ADDENDUM NO. 1

Venetia Valley TK-8 School Landscape Renovations

Project Number #25-03

Addendum #1

SHEET NUMBER
ADDENDUM 1
L1.1

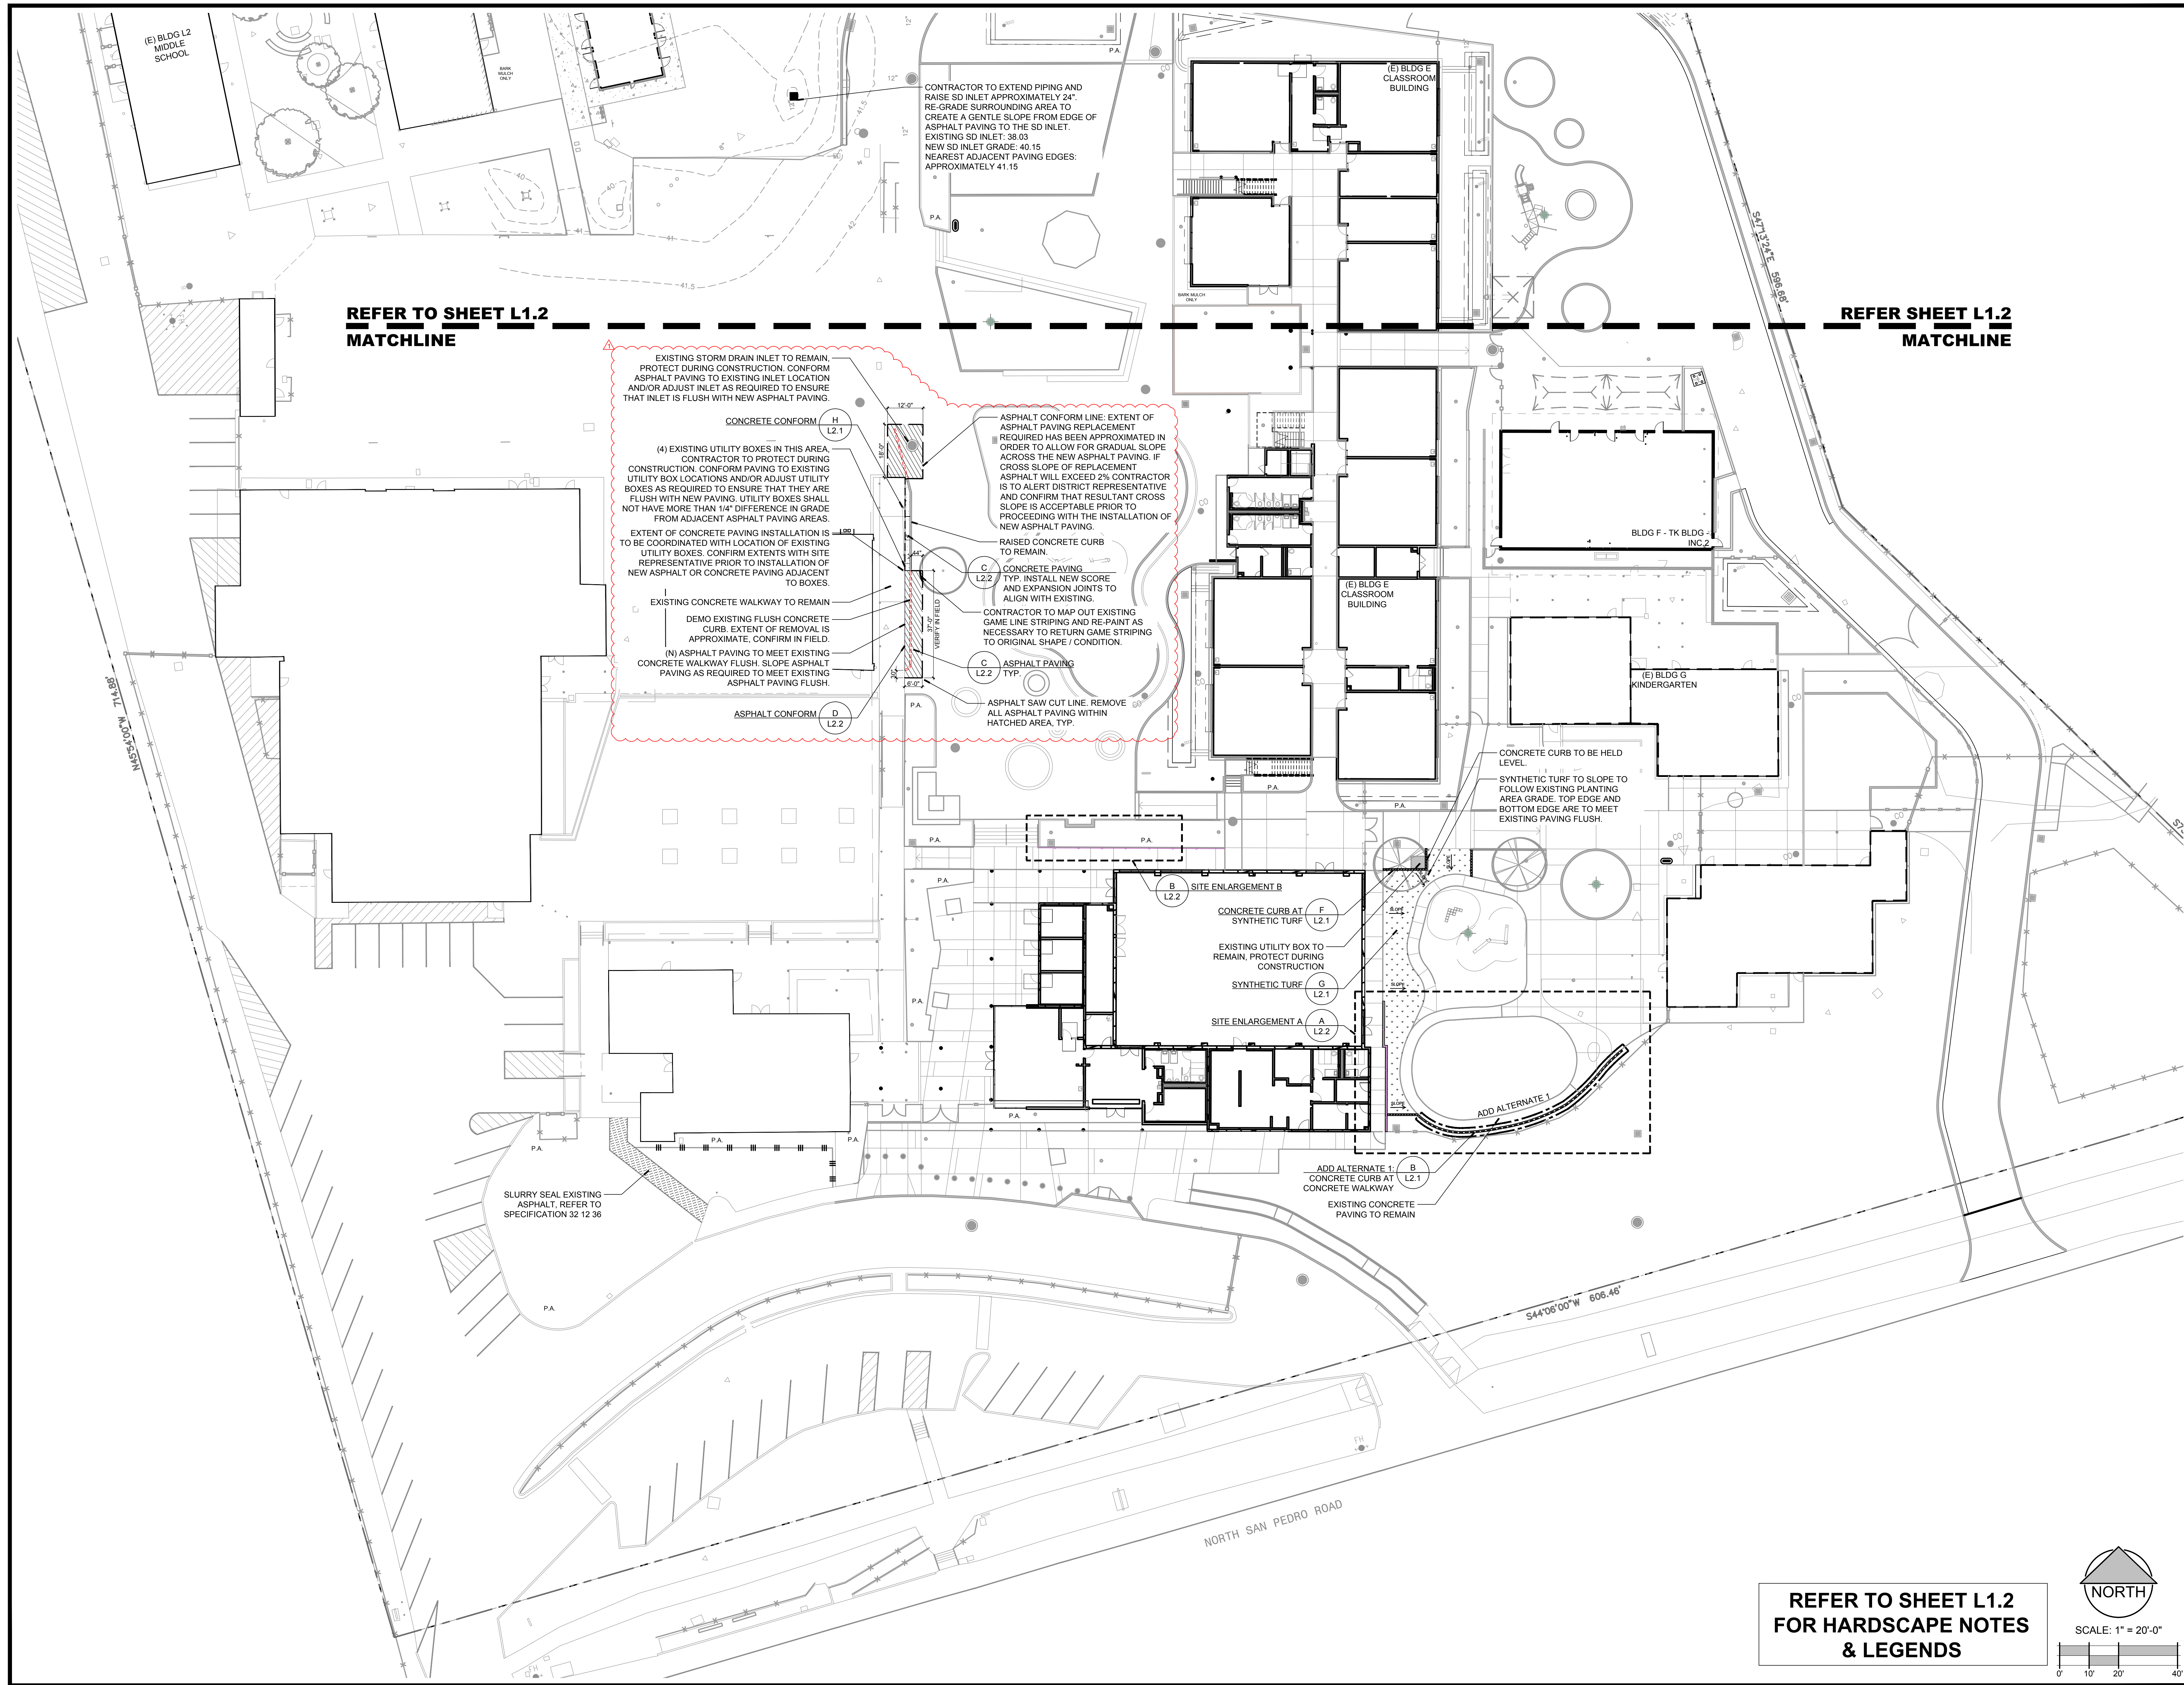
ITEM NO. 1.1: SHEET L1.1 HARDSCAPE PLAN:

Revise: Extent of curb demolition and asphalt / concrete paving replacement as shown clouded.

SHEET NUMBER
ADDENDUM 1
L1.2

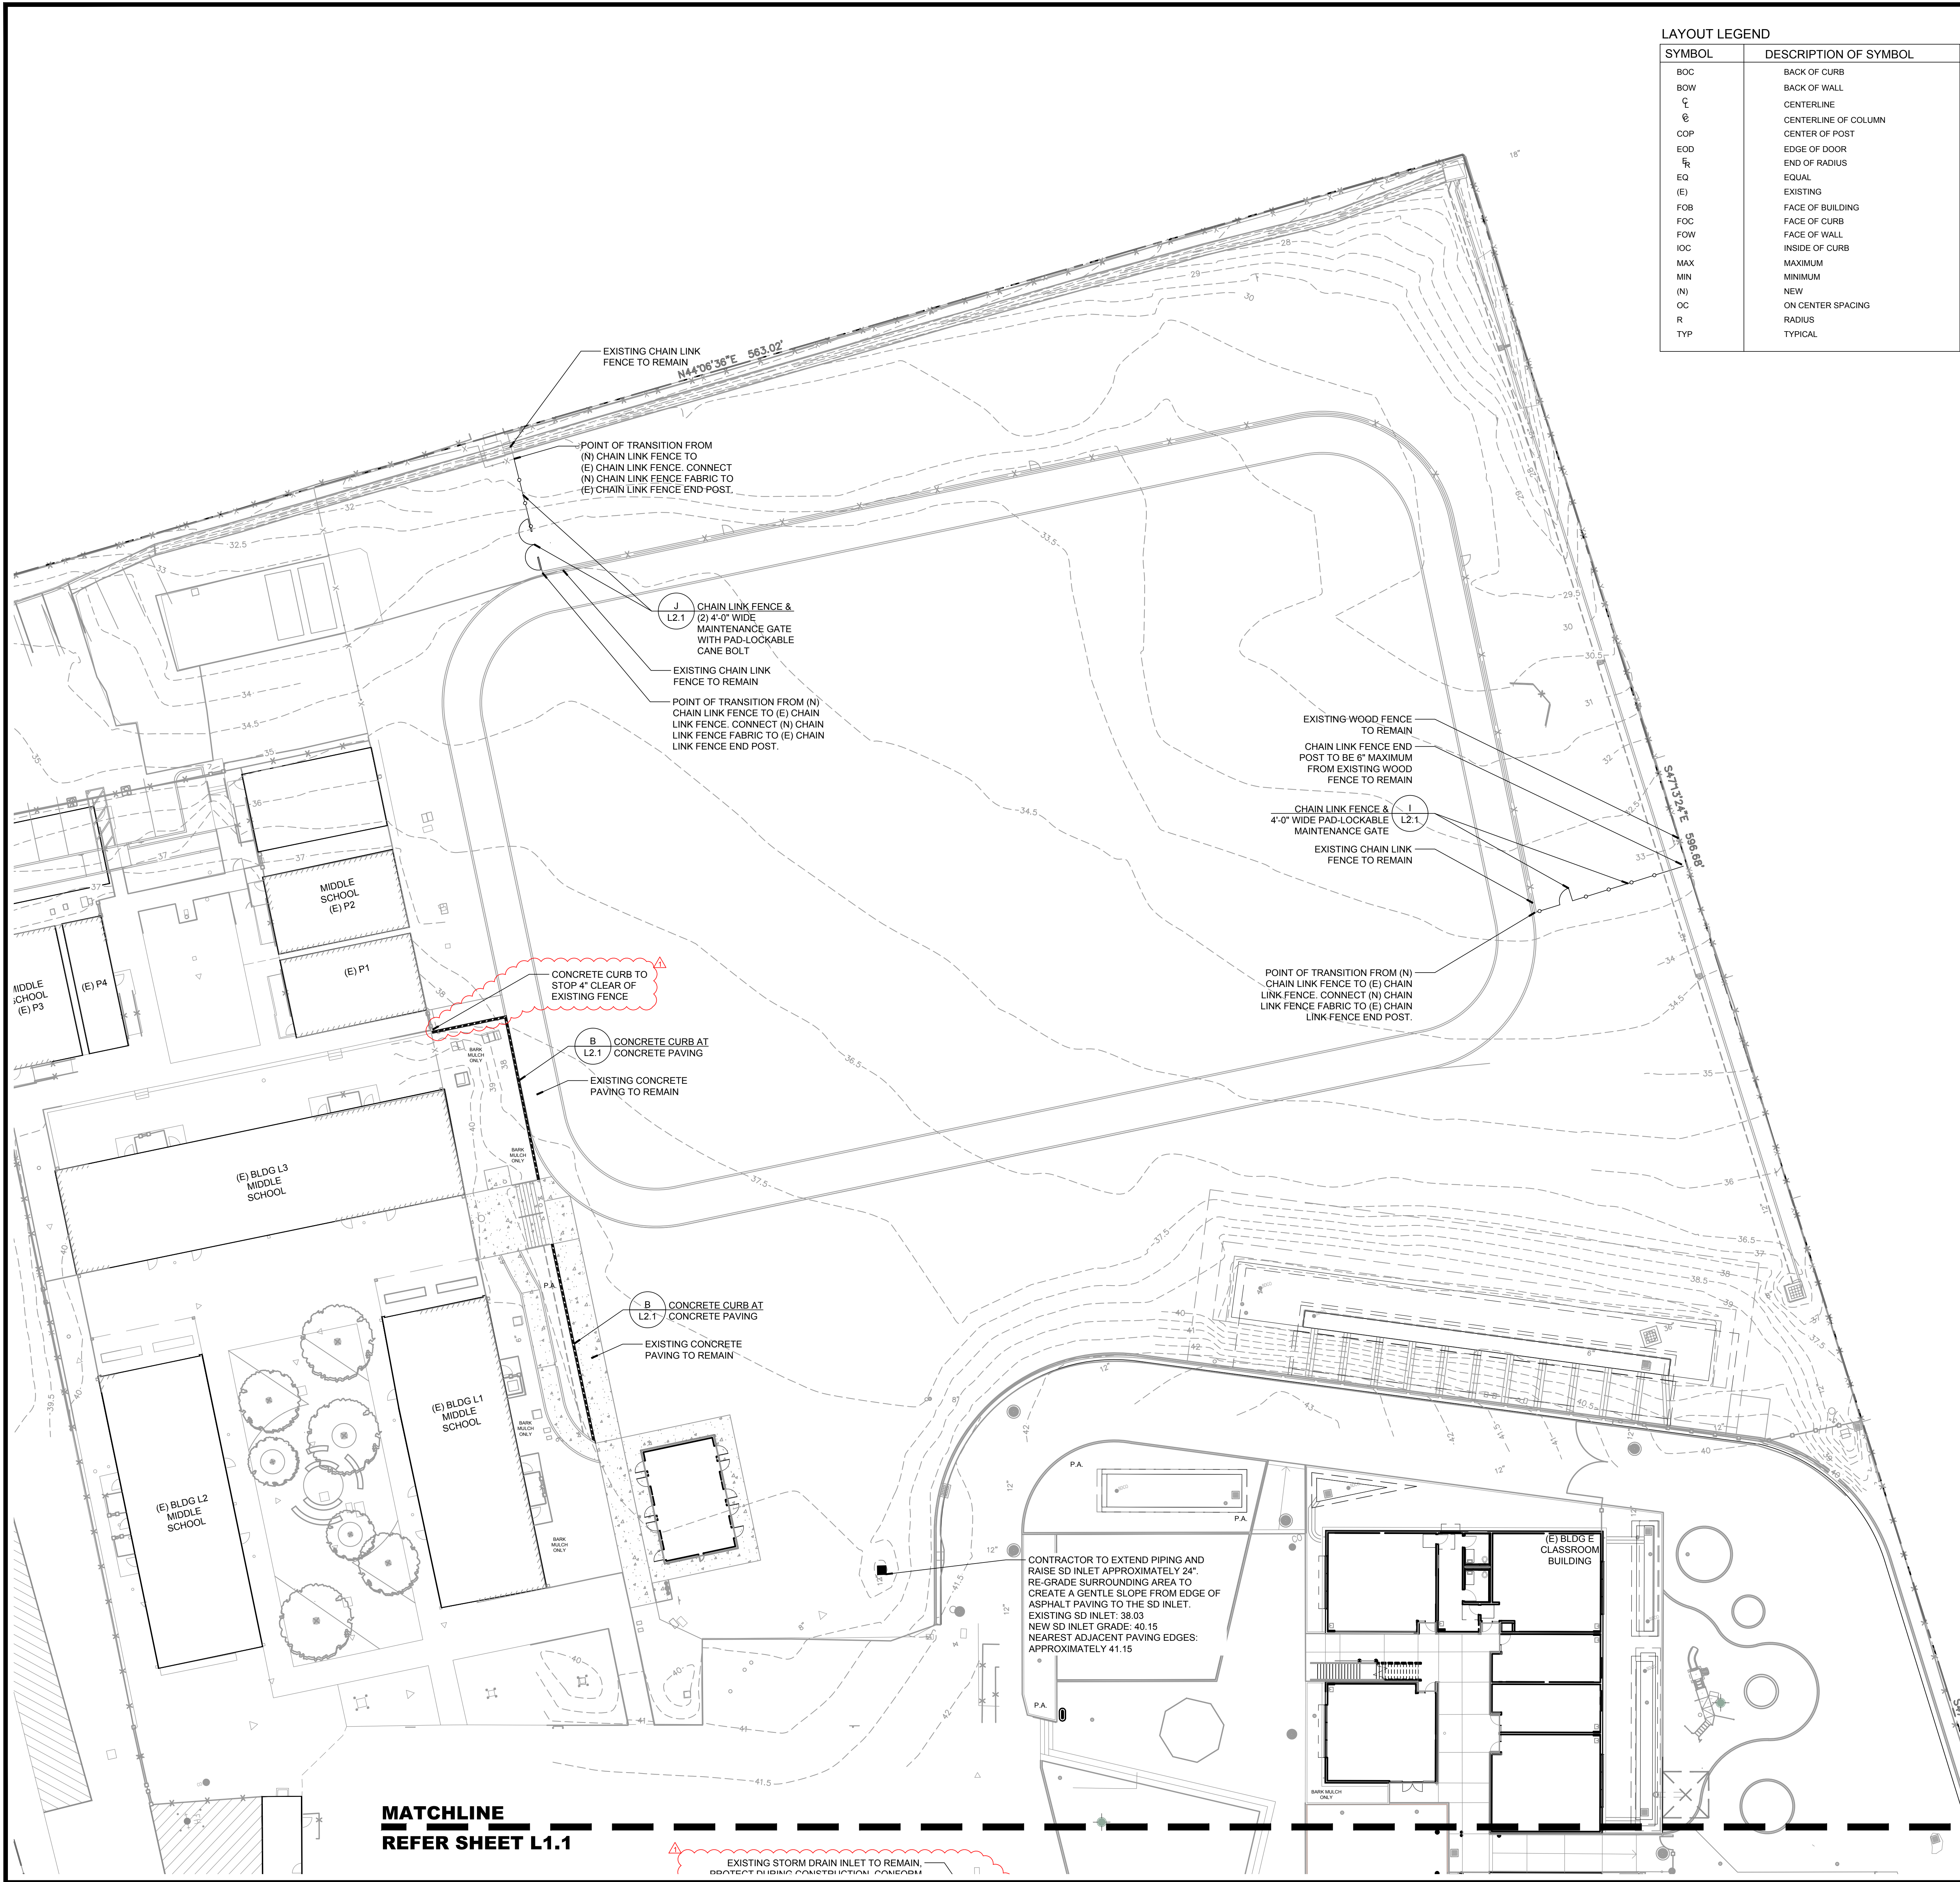
ITEM NO. 1.2: SHEET L1.2 HARDSCAPE PLAN:

Add: Approximately 23'-0" of Concrete Curb at Concrete Paving (detail B / L2.1) as shown clouded.

Revise: Material Legend to include Concrete Paving, Expansion Joint, Tooled Score Joint, and Concrete Conform Line as shown clouded.

H CONCRETE CONFORM SCALE: NTS

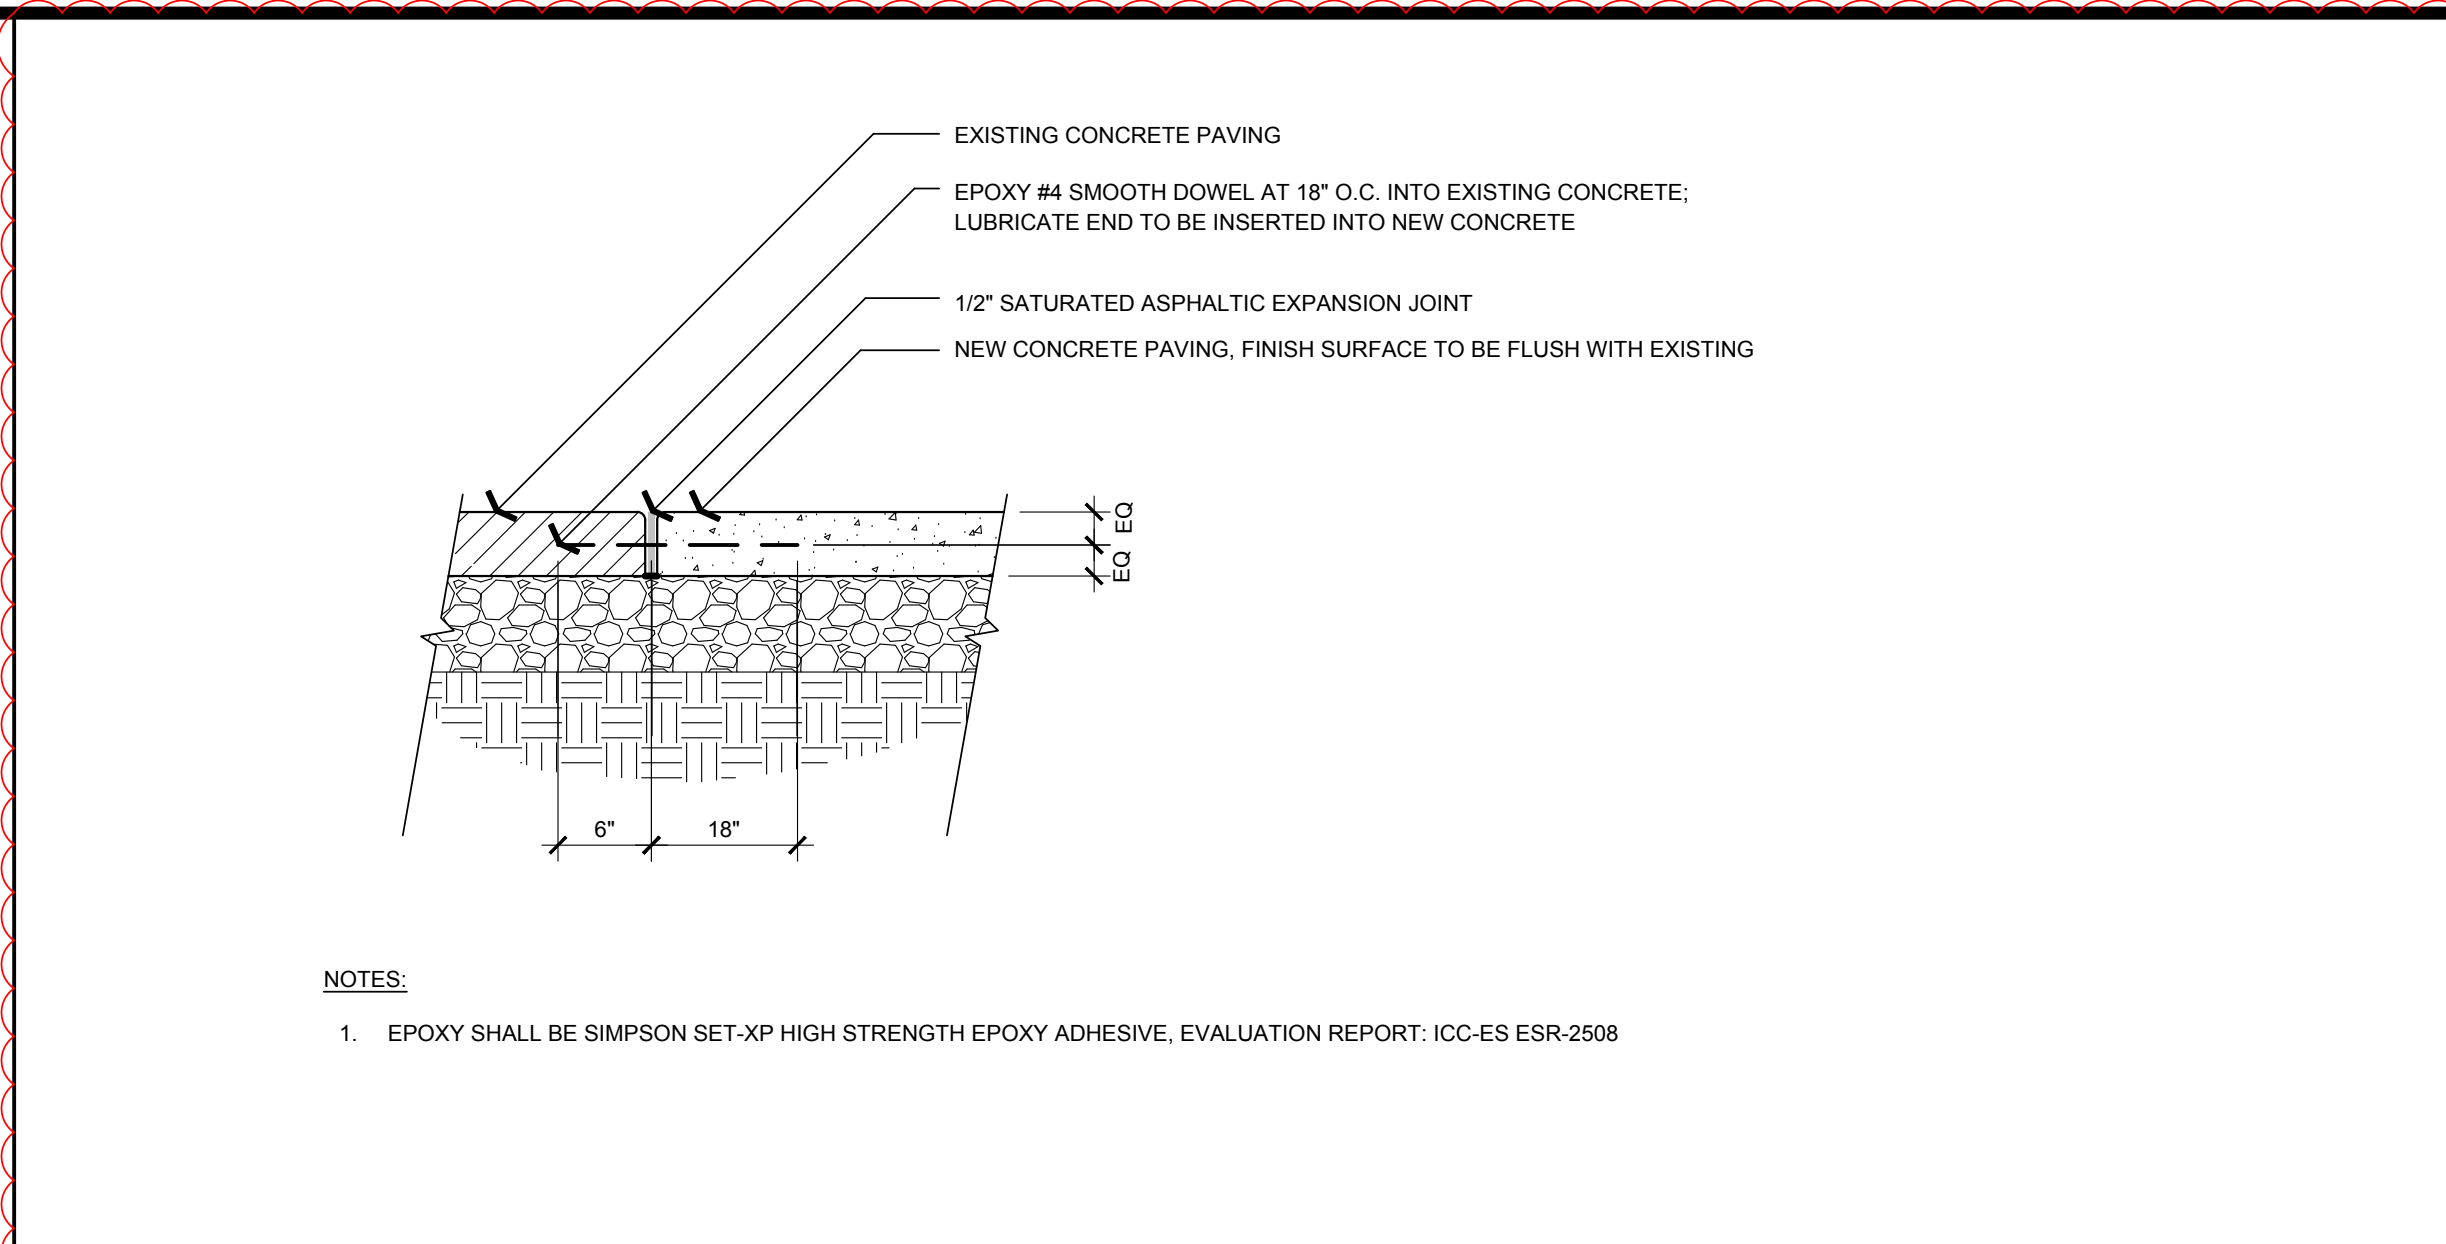
Add: Detail H "Concrete Conform" detail in its entirety.
